**RFP# 4246 - Addendum #2  
Masonry and Windows Replacement  
AJ Smeltzer Junior High School**

Date: June 18, 2024

SCALE: N.T.S.  
DATE: JUNE 2024  
PROJECT No.: 2020-137  
SHEET No.: **S-101**

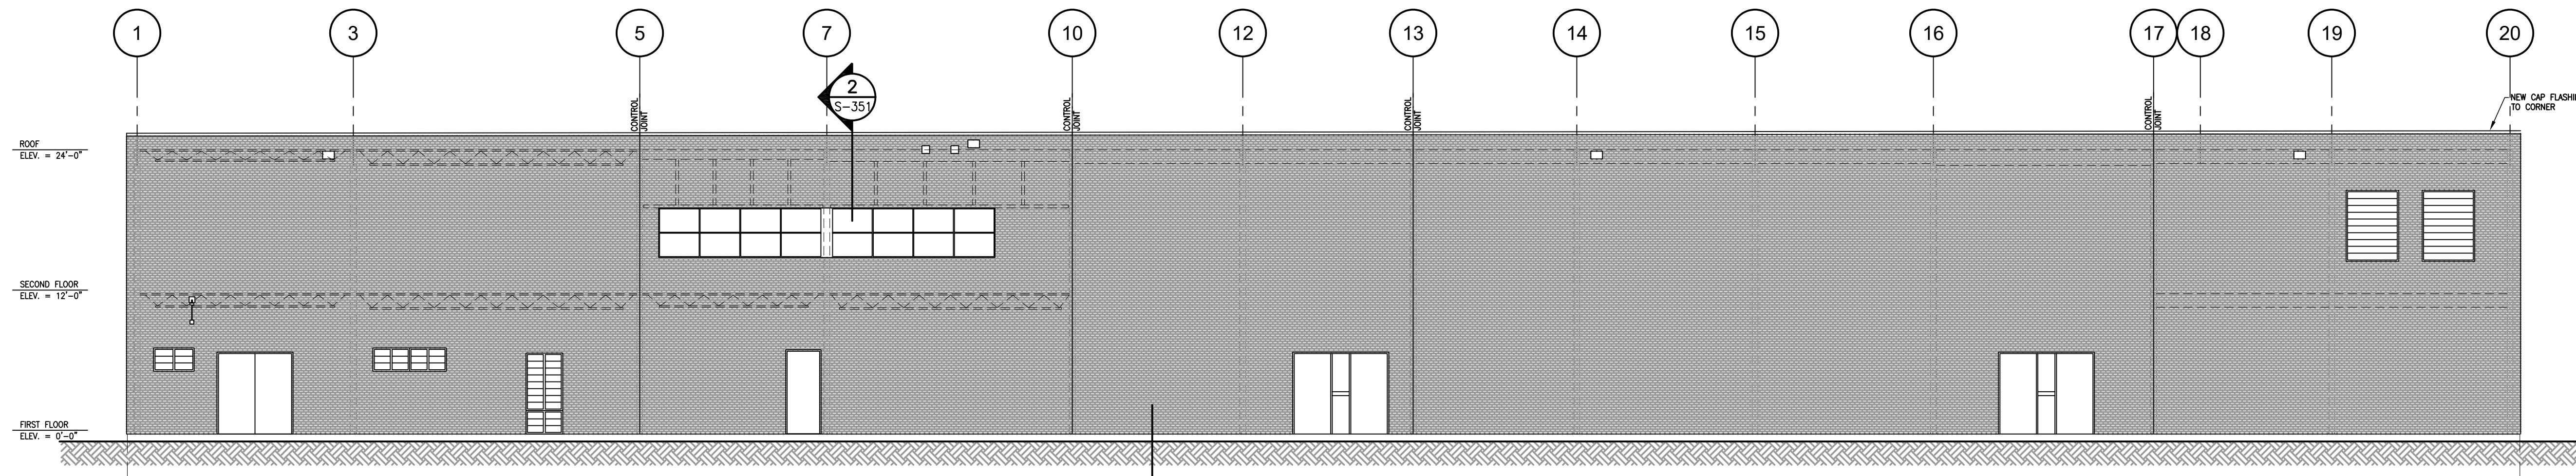
- .1 Add the following structural drawings, regarding work related to steel base plates, steel decking, steel lintels, and ductwork brackets.
  - .1 S-101, S-201, S-202, and S-351.
